2.C.2.1
JHG 81-165
ATOMIC POWER COMPANY •

July 28, 1981
FMY 81-112

Subject: Maine Yankee Fuel Storage Modification

Enclosed herewith are responses to the vendor design specific questions which were not available at the time of our letter, Reference (b). This information completes our obligations in response to your letters References (c) and (d).

INTERNAL STAINLESS STEEL	DESIGNED BY	T. T. B.
HEAT TREATMENT	CHECKED BY	J. GARDNER
FINISH	DATE	6.28.54
UNITED STATES PATENT OFFICE	APPROVED BY	
REGISTERED TRADE MARK	MODEL NO.	P. 31146-B
DESIGNED AND DRAWN BY	HEAT TREAT	
SCALE 1/4" = 1"	SCALE 1/4" = 1"	
	NO. P. 31146-D

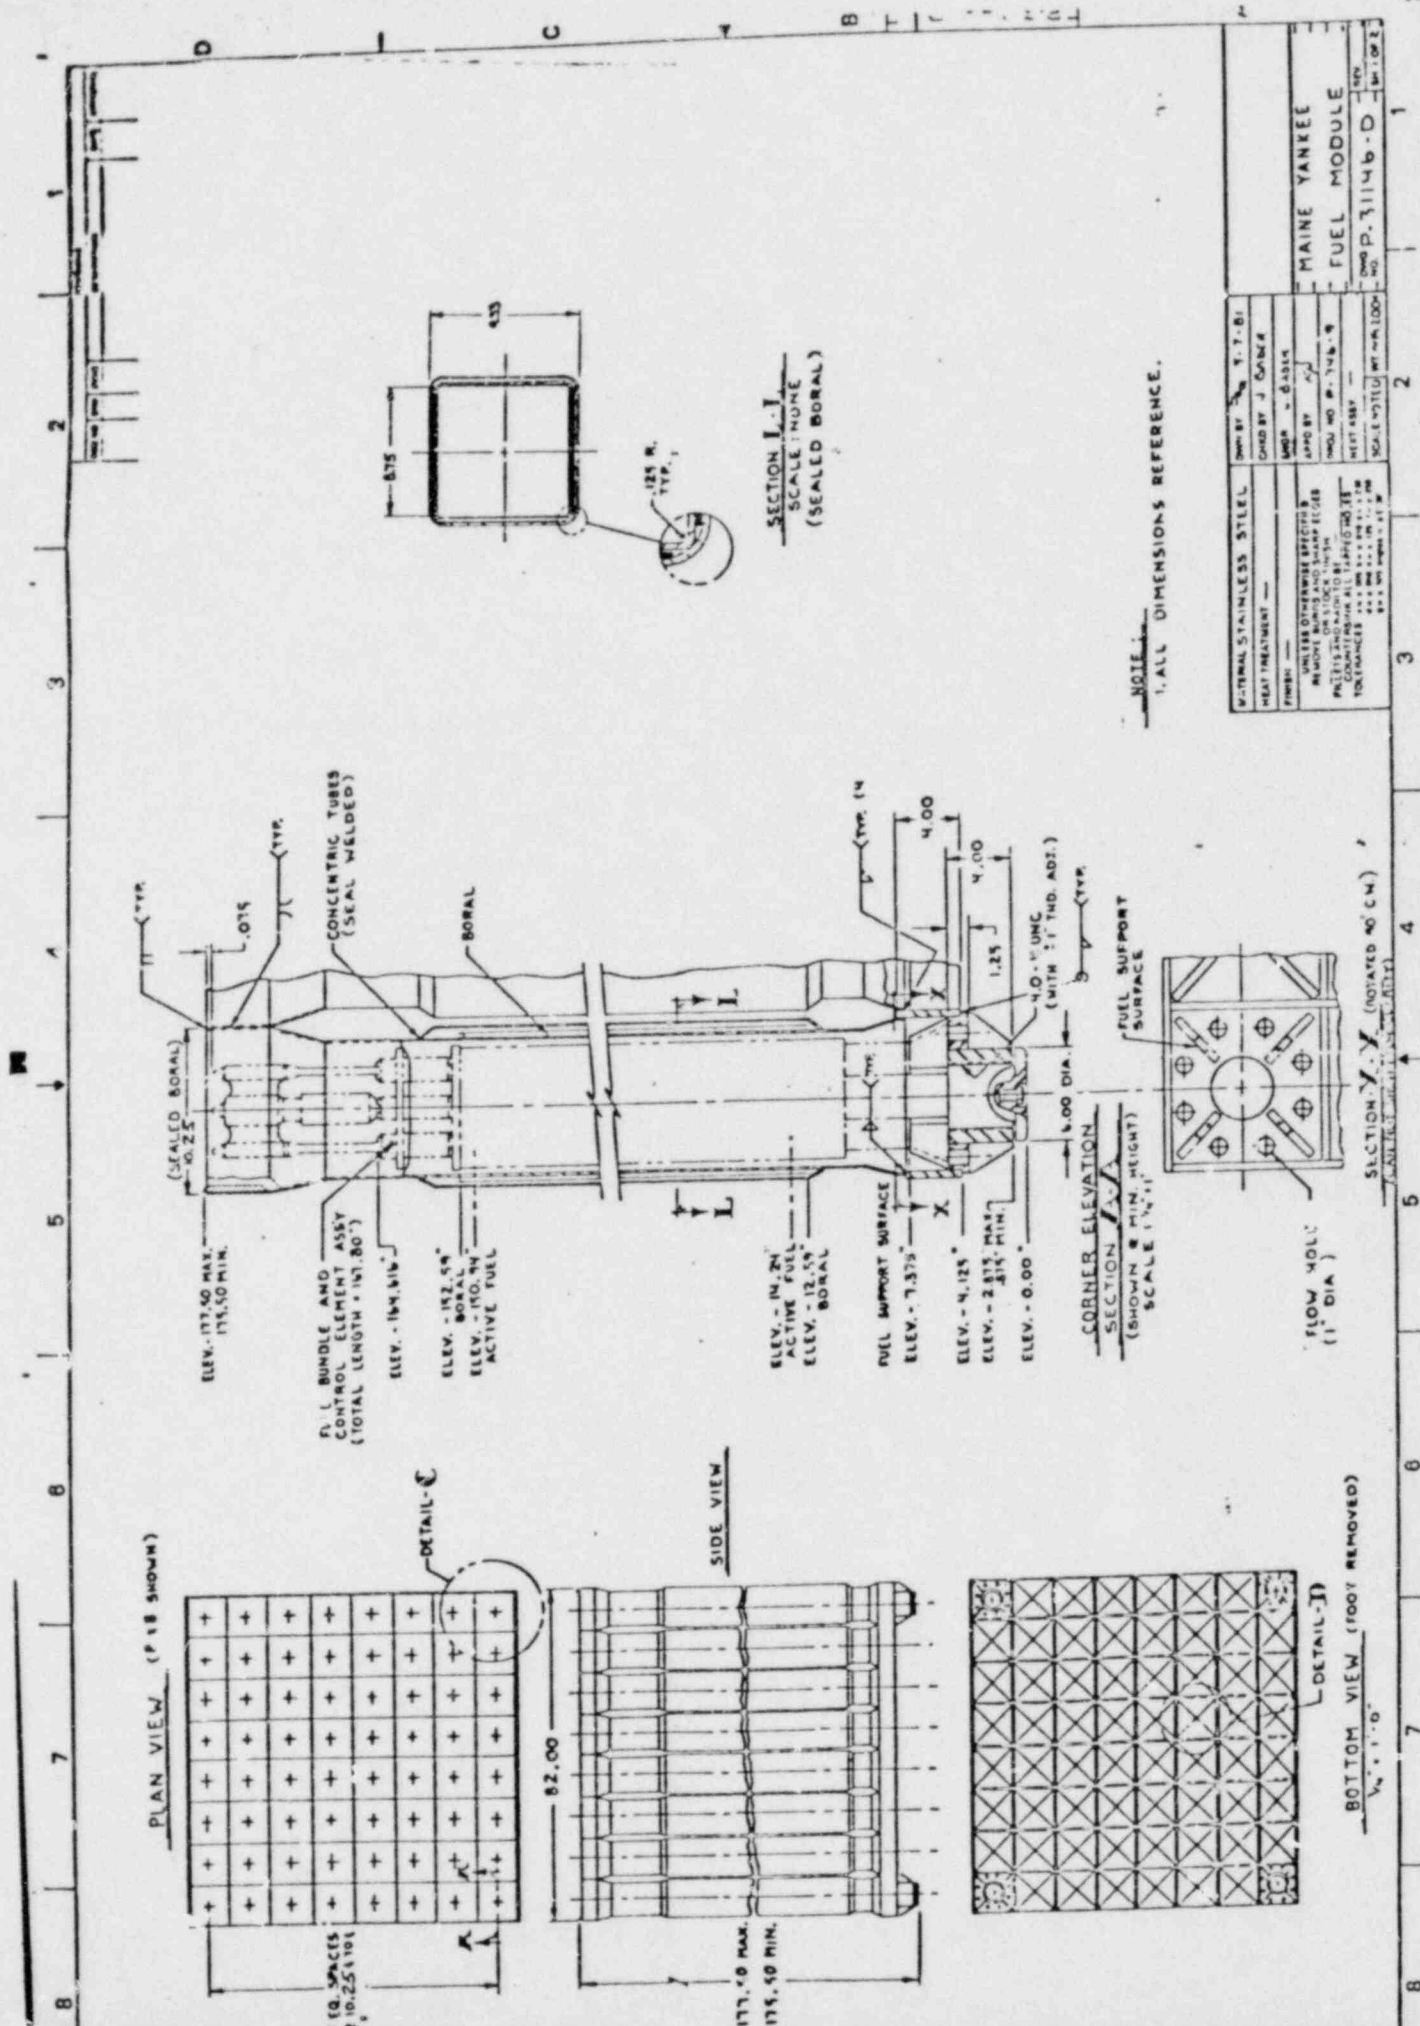
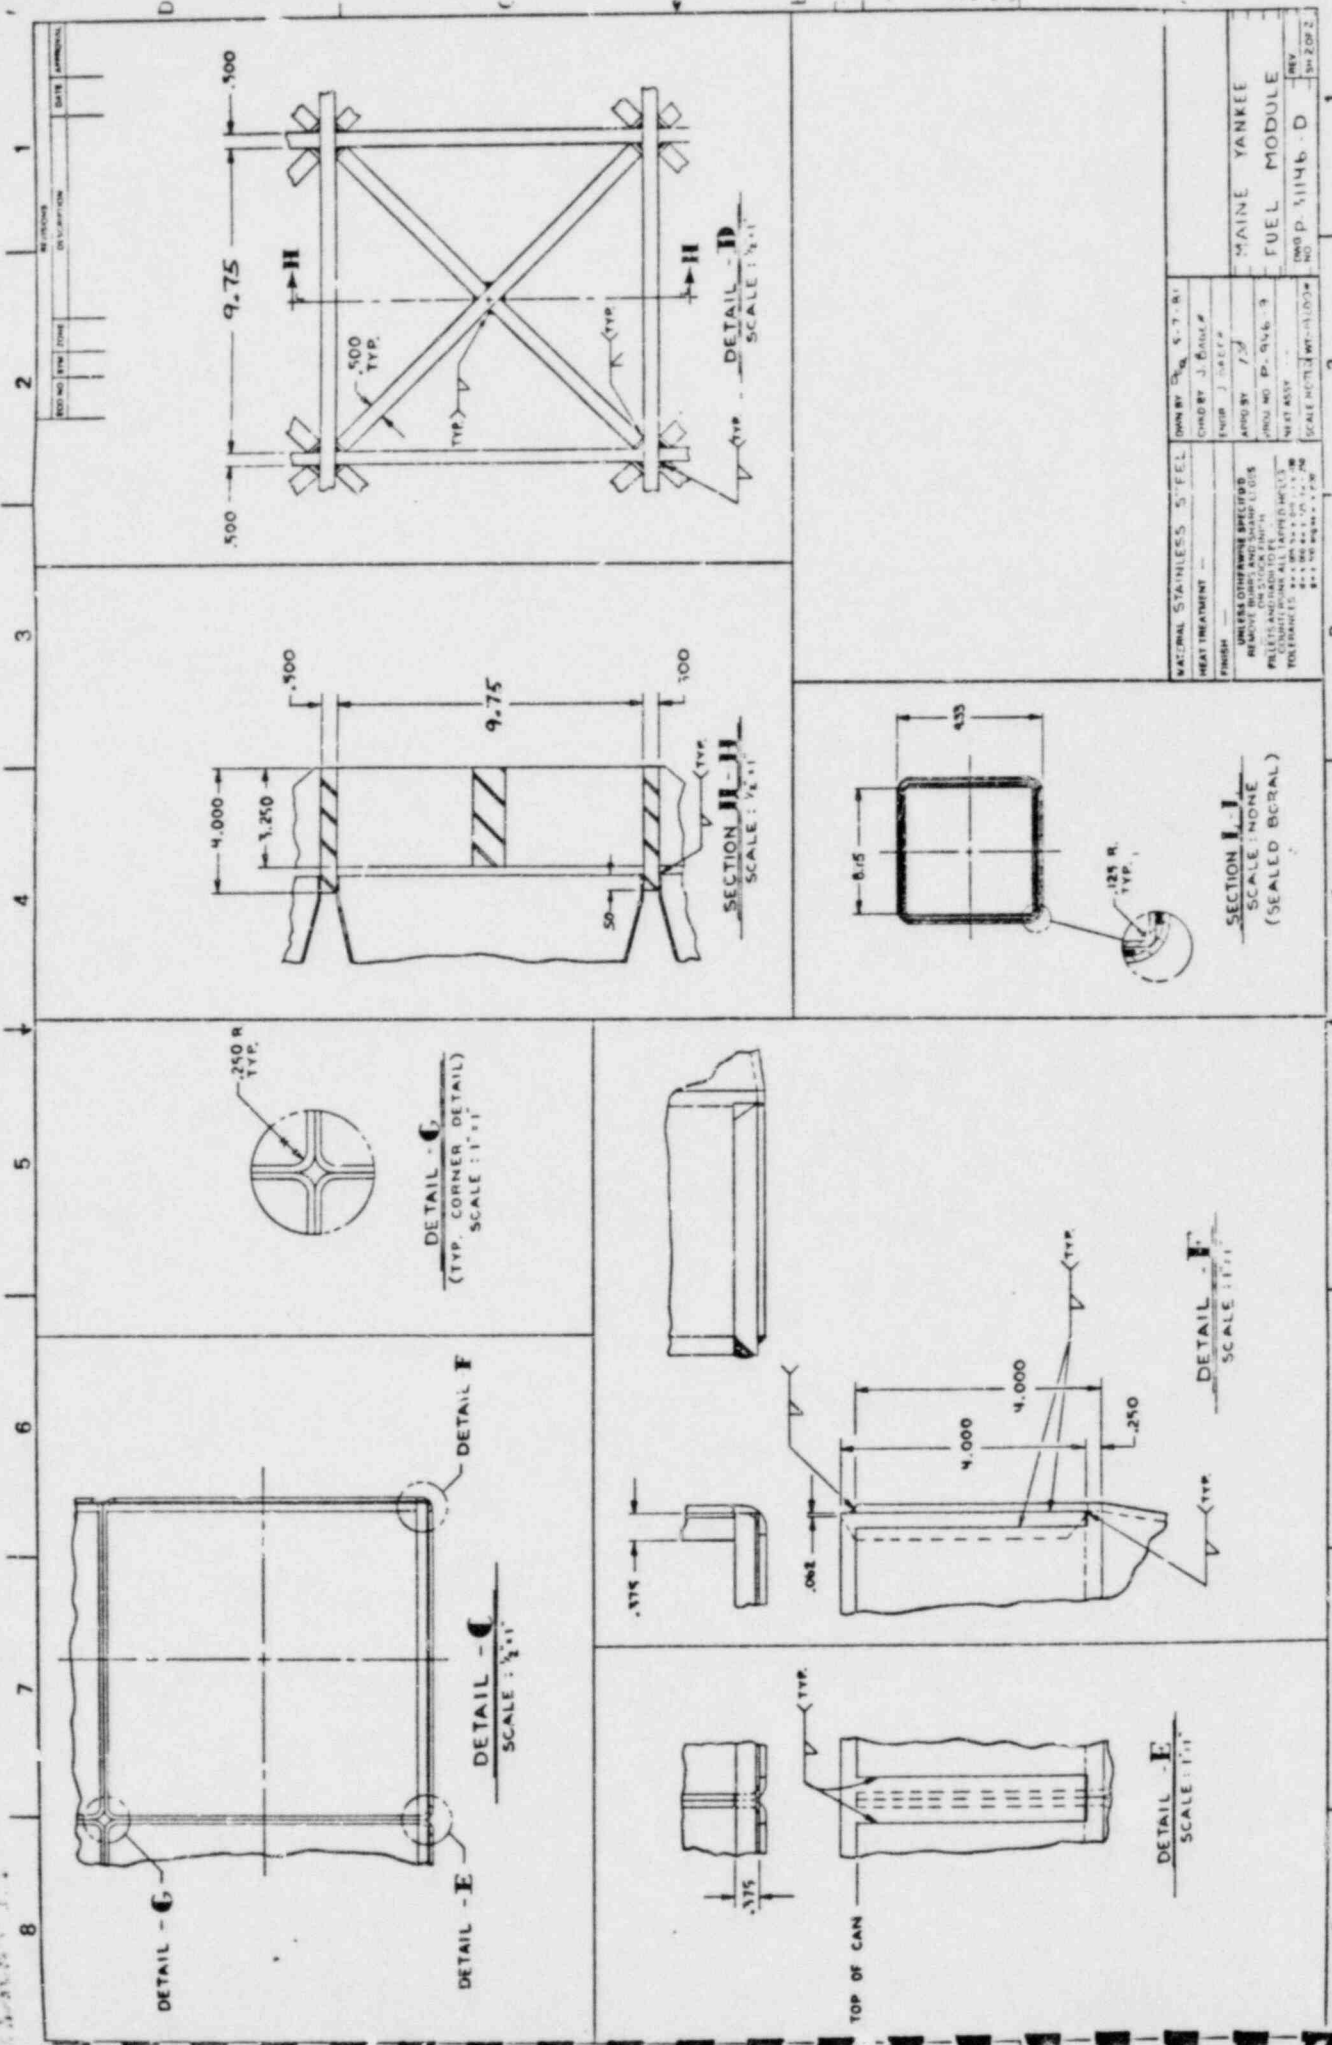
Provide sufficient details (discussion, sketches and schematics) of the racks, rack base supporting structures, racks arrangement in the pool, the spent fuel pool, and all gaps (clearance and expansion) of the rack structure and fuel bundles.

See Attachment I, Section 3.0, 3.1 and 3.2; and Drawing No. P-31146-D, sheets 1 and 2.

Due to the gaps between assemblies and the wall of the guide tubes, additional loads will be generated by the impact of the fuel assemblies during a postulated seismic excitation and sliding. Provide the justifications and the numerical values of these dynamic magnification factors due to the impact. Provide, also, sufficient details describing the gaps, the guide tubes and the boundary conditions of the fuel bundle inside the guide tubes.

See Attachment I, Section 4.0, Section 5.0, and Figure 3.1.
